RE: JMC Project 22090
BaySpace Armonk
100 Business Park Drive
Town of North Castle, NY

Response to Town Comments Resubmission

Town of North Castle Planning Department Memorandum, dated June 19, 2023

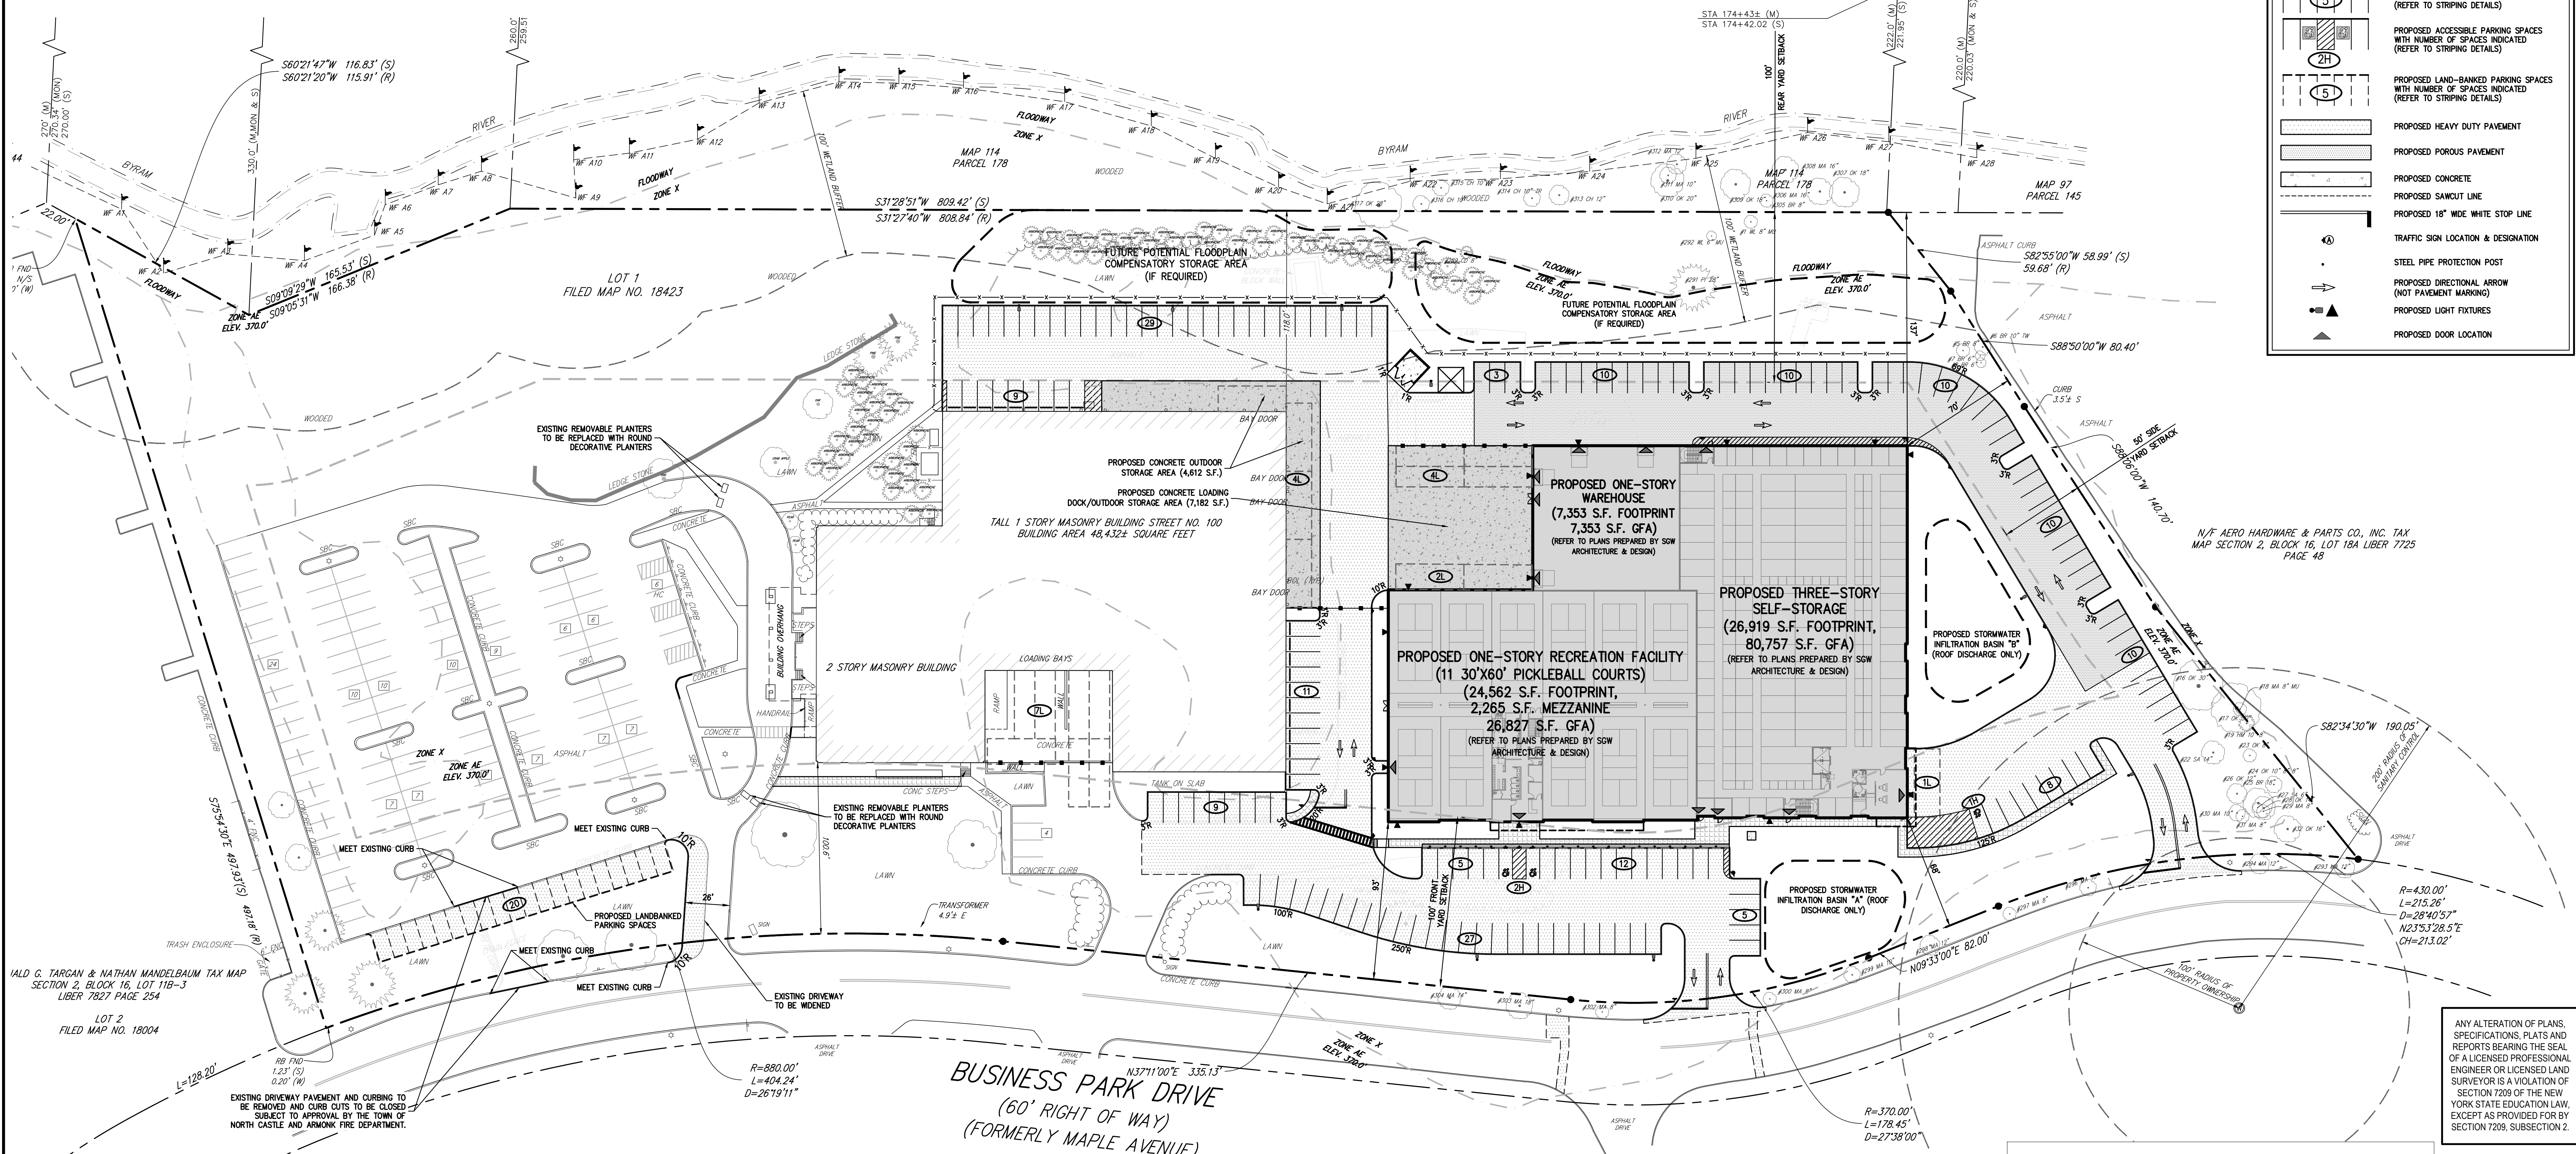
The plans need to indicate the locations of all fire hydrants. Please make sure this meets NYS Fire code appendix D, section D10.1 Access Road width, with a fire hydrant.

The plans need to show compliance to the NYS 2020 Fire code, D103.6 signs.

The plans need to show compliance to the NYS 2020 Fire code, D105 Aerial Fire Apparatus Access Roads especially section D105.3 Proximity to the building.

The location of the proposed fire hydrant in the front of the proposed building is depicted on the plans, refer to Drawings C-100 and C-300.

Proposed "No Parking Fire Lane" signs have been added to the plans in accordance with NYS Fire Code Section D103.6, refer to Drawing C-100.

The proposed 26-foot wide aerial fire apparatus access roads are located no closer than 15 feet and no farther than 30 feet from the proposed building in accordance with NYS Fire Code Section D105.3, refer to Drawing C-100.

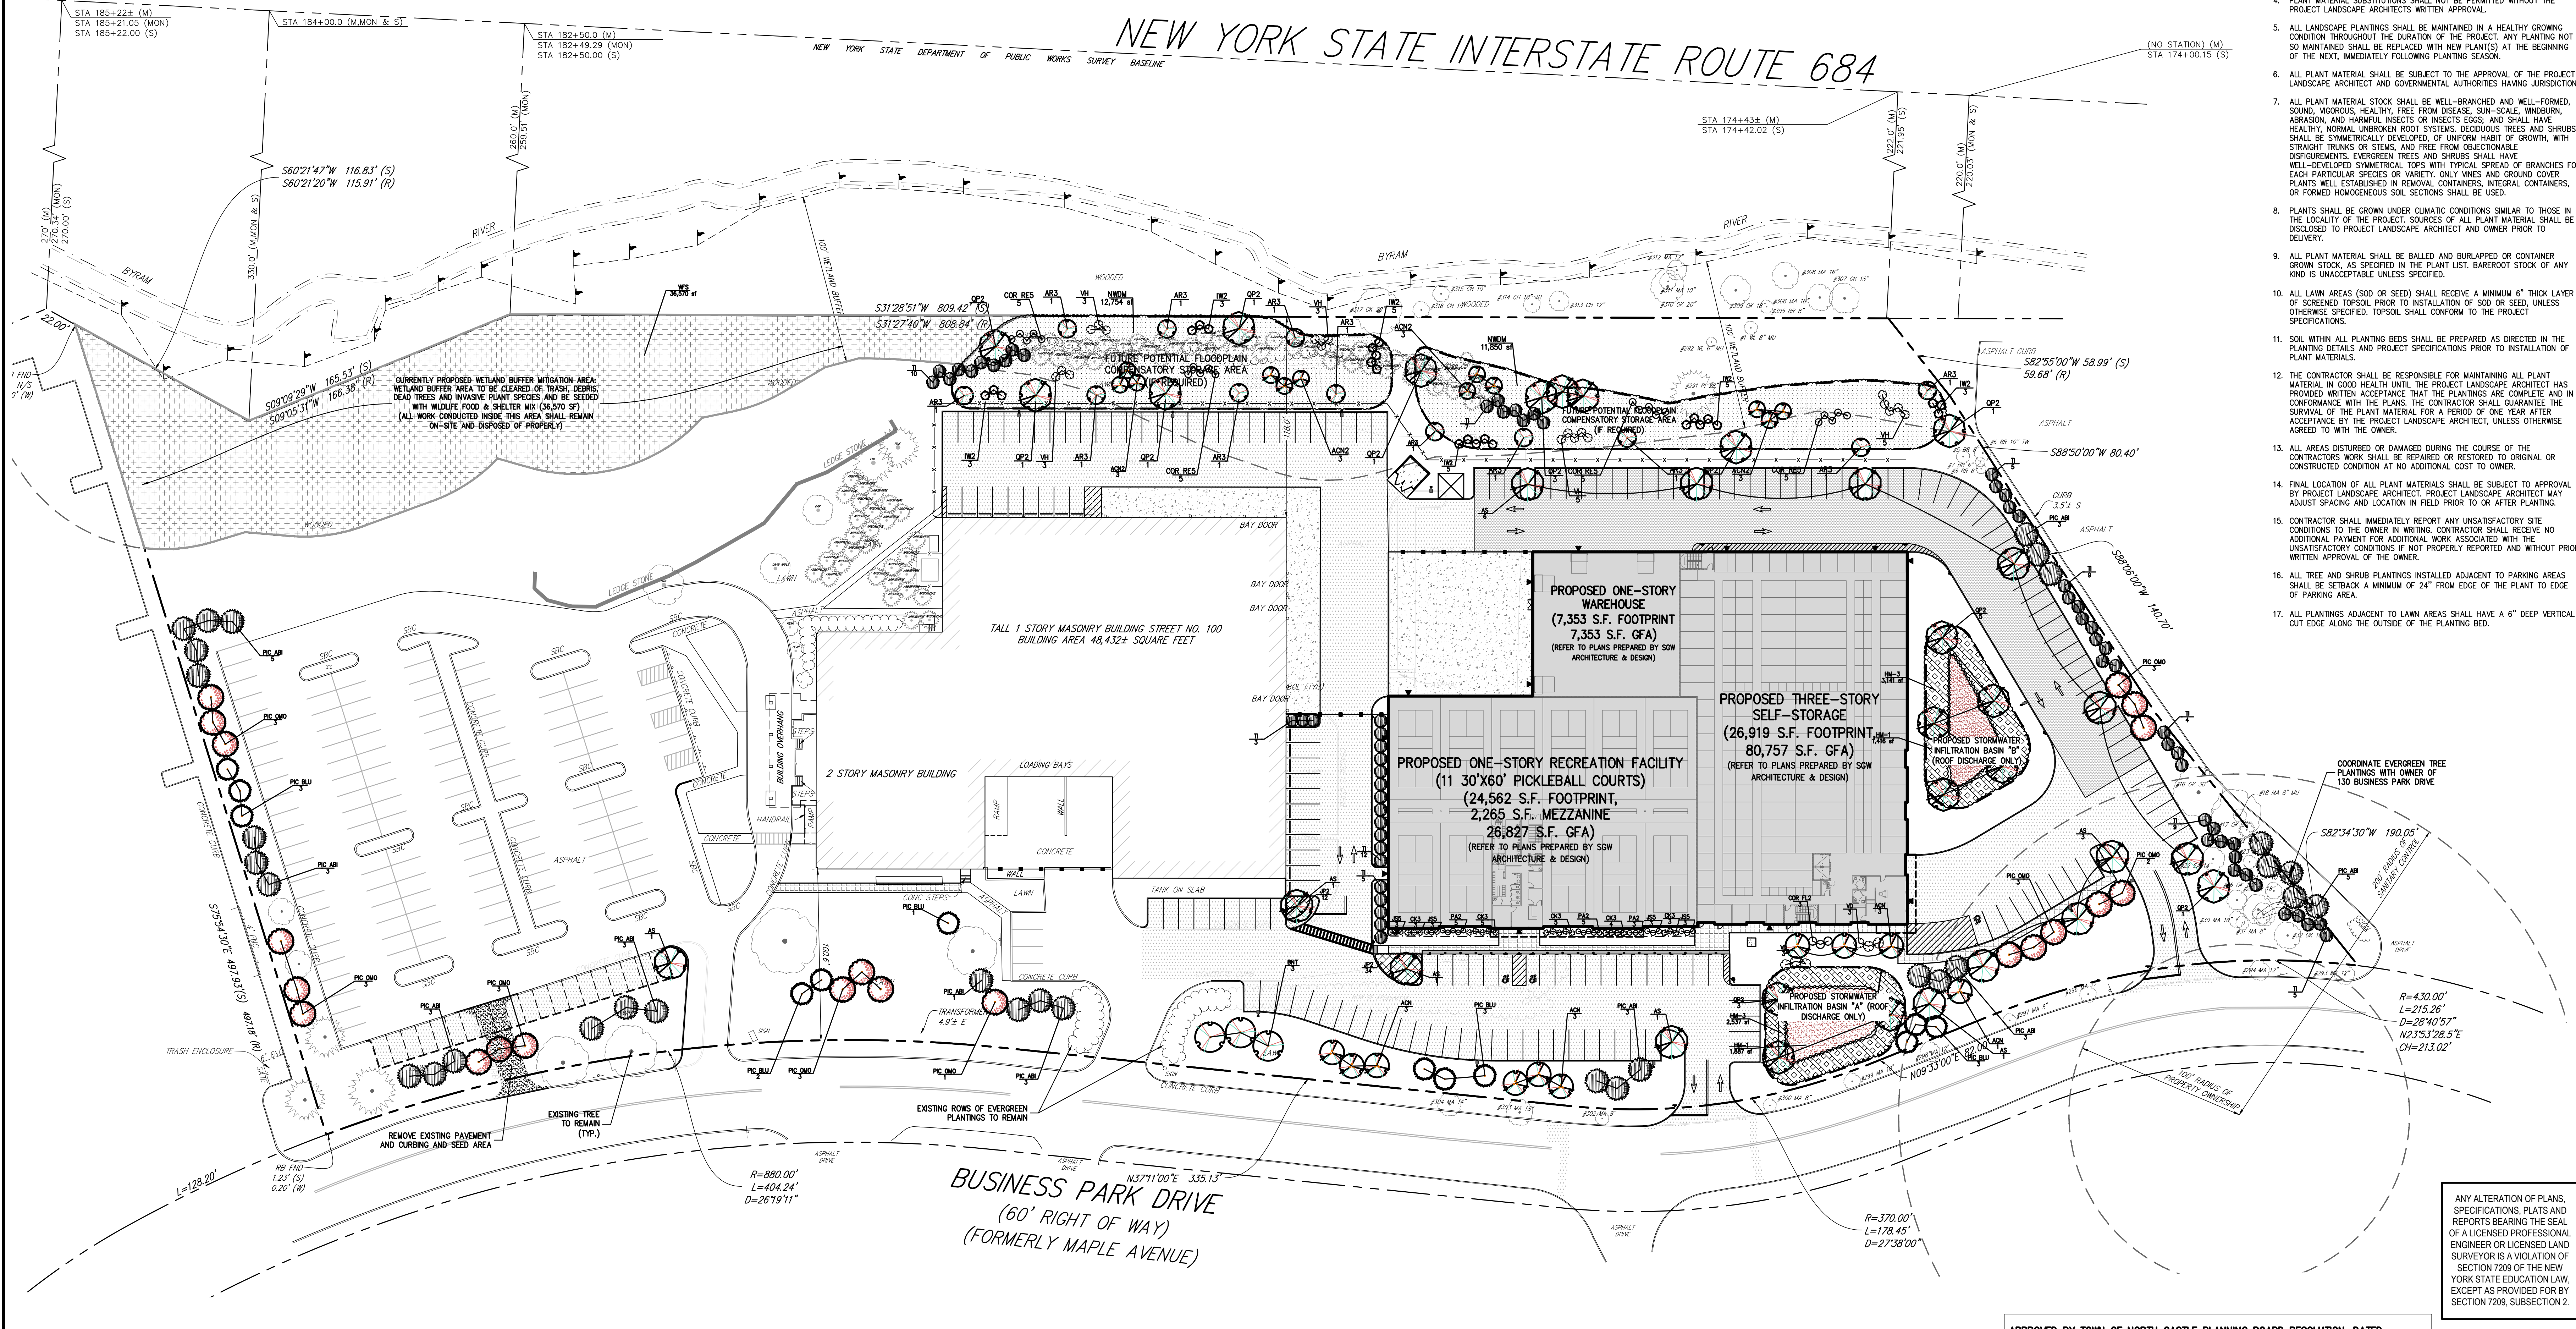
The Byram River is located at the rear of the property. The site plan should be revised to depict the proposed amount of Town-regulated wetland buffer disturbance. A mitigation plan that is twice the size of the proposed amount of disturbance is required to be submitted.

The proposed wetland buffer disturbance area is 5,615 SF/0.128 AC, and the proposed wetland buffer mitigation planting area is 36,570 SF/0.839 AC, these areas are depicted on Drawings C-500A and C-500.
